March 29, 2016
L-2016-064
10 CFR 50.90

Re: Turkey Point Units 3 and 4
Docket Nos. 50-250 and 50-251
Response to Request for Additional Information Regarding
License Amendment Request No. 237, Application to Revise
Technical Specification Figure 3.1-2, Boric Acid Tank Minimum Volume

**Response to Request for Additional Information Regarding
Turkey Point Units 3 and 4 License Amendment Request No. 237:
Application to Revise Technical Specifications Figure 3.1-2,
Boric Acid Tank Minimum Volume**

Figure 4.1: Elevation view of typical boric acid storage tank (not to scale—Reference 2.18)

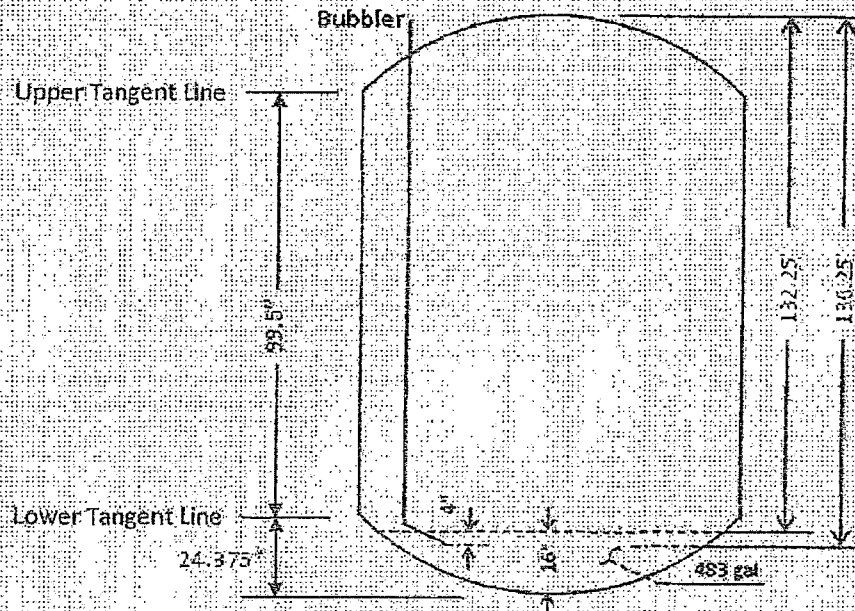
EICB RAI-5b.

Is the tank interconnection at a level that does not affect the accuracy of the level measurement system?

The BASTs are interconnected with 3 inch pipes at the bottom of each tank. The vortex height of each tank is 16 inches. The bubbler tube outlet for the level instrumentation is 4 inches below the top of the vortex level. Therefore, the useable range has been established from 4 inches above the outlet of the bubble tube to the top of the tank. As such, the BASTs interconnection does not affect the accuracy of the level measurement system. An excerpt from Calculation 25489-000-JLC-BG-00001 has been included below to further illustrate the vortex height and the useable range of the BASTs.

- 4.1.5 The full height of the BASTs is 148.25 inches, and subtracting the vortex height (16 inches) the useable height of the tank is 132.25 inches. The bubbler tube outlet for the level instrumentation is 4 inches below the vortex level (References 2.2, 2.17 & 2.18). Therefore, the useable range is from 4.0 inches above the outlet of the bubble tube to 136.25 inches above the outlet of the bubble tube (i.e., 4"-136.25").
